COUNTY OF VENTURA
PUBLIC WORKS AGENCY

Addendum No.2

Subject: **Project Name: E.P. Foster Library Modernization**
Specification No. CP24-01
Bids to be Opened Wednesday, January 14, 2026

Addendum No. 2

SHEET NO A-400

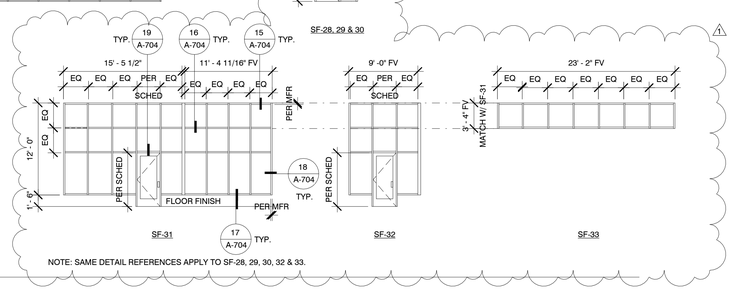
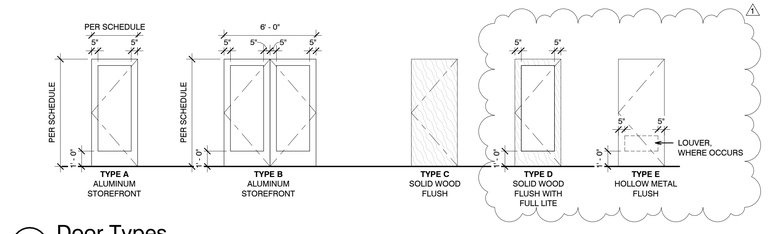
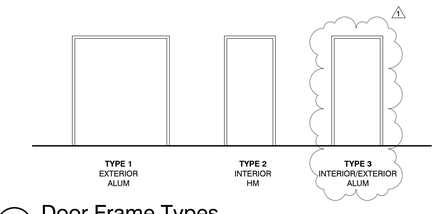
1. Replace Sheet A-400 Door Schedule with attached Addendum No. 2 Sheet A-400 Door Schedule.
   Explanation: See revision clouds. Door schedule and storefront detail references have been updated.

A-703

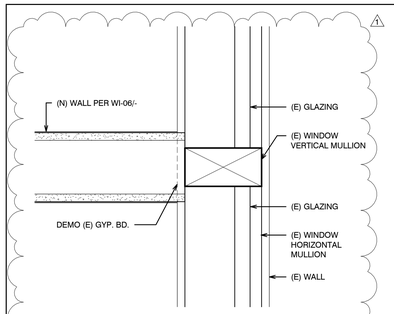
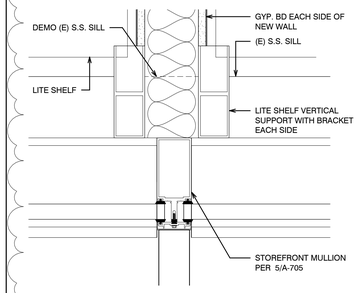
2. Replace Sheet A- 703 Wall Types & Misc Details with attached Addendum No. 2 Sheet A- 703 Wall Types & Misc Details.
   Explanation: See revision clouds. Wall to (N) Storefront & Wall to (E) Window details are updated. Transition details have been added.

10 Reglet Mounted Counterflashing
SCALE: 1 1/2" = 1'-0"

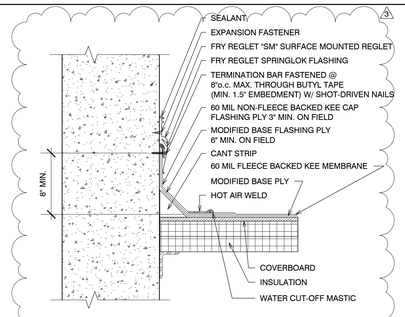
3. Replace Sheet A-707 Roof Details with attached Addendum No. 2 Sheet A-707 Roof Details.
   Explanation: See revision clouds. New Roof Detail 9 - Roof Metal Drip Edge and new Detail 10 - Reglet Mounted Counterflashing have been added.

7 Roof Hatch & Ladder
SCALE: 3/4" = 1'-0"

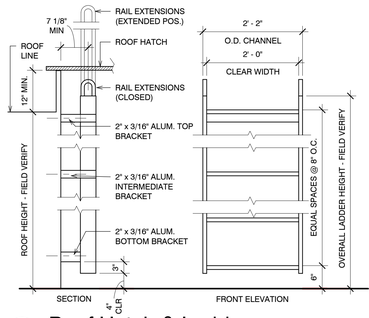
16. *Question: Does the upper roof require a roof hatch?*

Reply: Yes, install a new roof hatch and a ladder similar to that specified for the lower roof (Topping Room), at or near the existing roof ladder into the penthouse. Height from finish floor to roof at that location is approximately 12'-8".
